Notice of market rule modification

Paper No.	EMC/RCP/13/2004/232
Rule reference:	Alternate Default Bus
Proposer:	Chen Jianhong (Market Operations, EMC Pte Ltd)
Date received by EMC:	10 March 2004
Category allocated:	2
Status:	Approved by EMA
Effective Date:	5 July 2004
Summary of proposed rules change:

PAPER NO. : **EMC/BD/03/2004/05(a)**

SUBJECT : **ALTERNATE DEFAULT BUS**

Figure 3

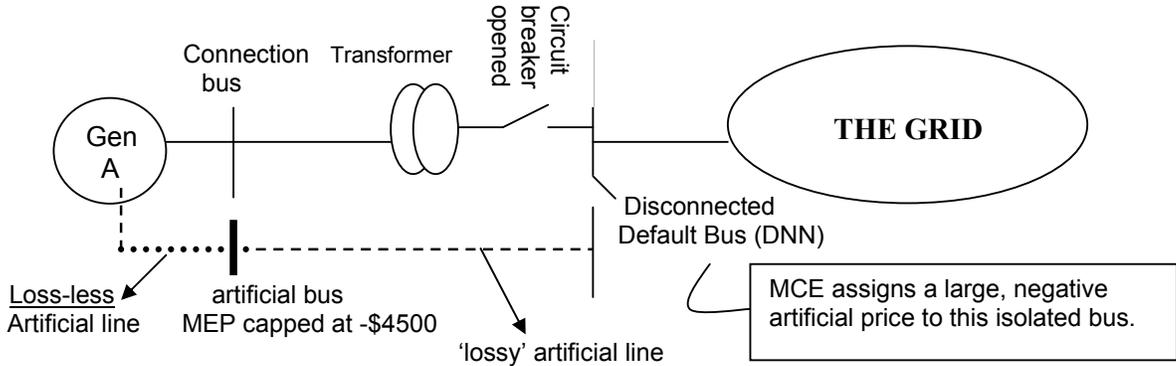
A problem will arise when the designated default bus of a disconnected generator also becomes isolated (i.e. physically disconnected). Please see fig. 3 above. The MCE solver will treat an isolated default bus as being 'undefined' and arbitrarily assign a very large and negative artificial price to it. If the generator also happens to be physically disconnected, then the MCE will establish a large negative price (capped at EnergyPriceMin of -\$4500) as the MEP for that generator.

Such MEP (-\$4500) is artificial and cannot be used for pricing/settlement purposes. If left unchecked, then the generator will be receiving payment instead of paying to the pool for consuming station load. Furthermore, under the vesting contract regime, MEPs are used to determine the VCRP of Gencos and MSSL for settlement purposes. Hence, EMC needs to revise the MEP by re-running the MCE with the isolated main default bus being replaced with an alternate default bus in the re-run environment.

Since market start, 4 such incidents have already occurred. An example of such incidents happened on 09 Jan 2004. That day, provisional MEP of -\$4500 for a generation facility which was not scheduled for generation was reported. The investigation showed that the main default bus for the generating facility was also isolated. This was confirmed by the PSO, who also indicated that during those affected periods, the generating facility was assigned to an alternate default bus. A re-run was done subsequently by using the alternate default bus (in place of the main default bus) in the re-run environment, so as the correct MEP for this generating facility could be determined.

It is proposed that the PSO designate a set of alternate default buses for generation registered facilities and generation settlement facilities so that these buses will be used by the MCE in its dispatch/pricing run when it encounters (via the NWSTAT) a situation when the generation facility and its designated main default bus are both disconnected from the PSO controlled system.

This proposal will require the PSO to designate an alternate default bus for each generation facility. The alternate default bus will be in the same substation/switchhouse as the designated main default bus. The losses between these two buses are negligible since the connection between them is essentially loss-less.
